HISTORIC PRESERVATION COMMISSION STAFF REPORT

Address: 14525 Montevideo Road, Poolesville **Meeting Date:** 09/08/99
Resource: Master Plan Site #18/39 **Report Date:** 09/01/99
 Rocklands
Review: HAWP **Public Notice:** 08/25/99
Case Number: 18/39-99A **Tax Credit:** Partial
Applicant: W. Landon & Cicely Banfield **Staff:** Perry Kephart

PROPOSAL: Rehabilitate loggia, grade driveway, reset kitchen steps, install drainage and downspouts.

Rocklands/Allnutt Farm #18/39
East Elevation

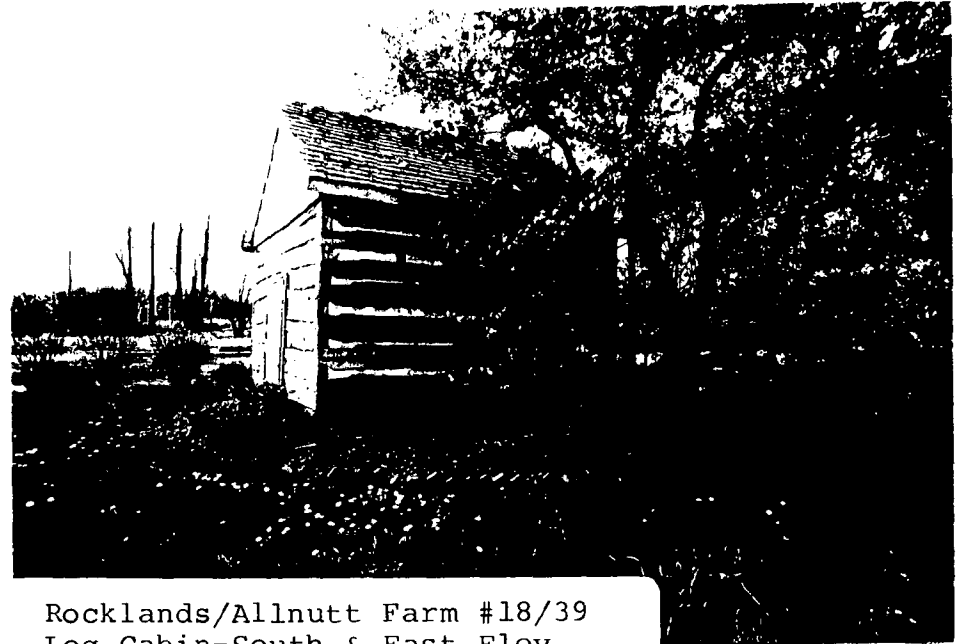
The proposed changes to the kitchen steps are more controversial. The inconvenient height of the risers appears to be an idiosyncrasy that has existed for many years. Staff is reluctant to support changes to historic features of the house. However, the steps lead to the most frequently used entrance to the house and are difficult, if not hazardous, to ascend, and tricky to descend. In the interests of safety, staff would concur with the proposed change. Although the steps are on the side of the house, they are readily visible. For that reason, staff would recommend that they be measured and photographed before they are reset.

2. The additional kitchen step(s) are to be of matching Seneca sandstone.
3. The existing kitchen steps are to be carefully documented and photographed before being changed.
4. Final design and materials of downspouts to be approved at staff level.
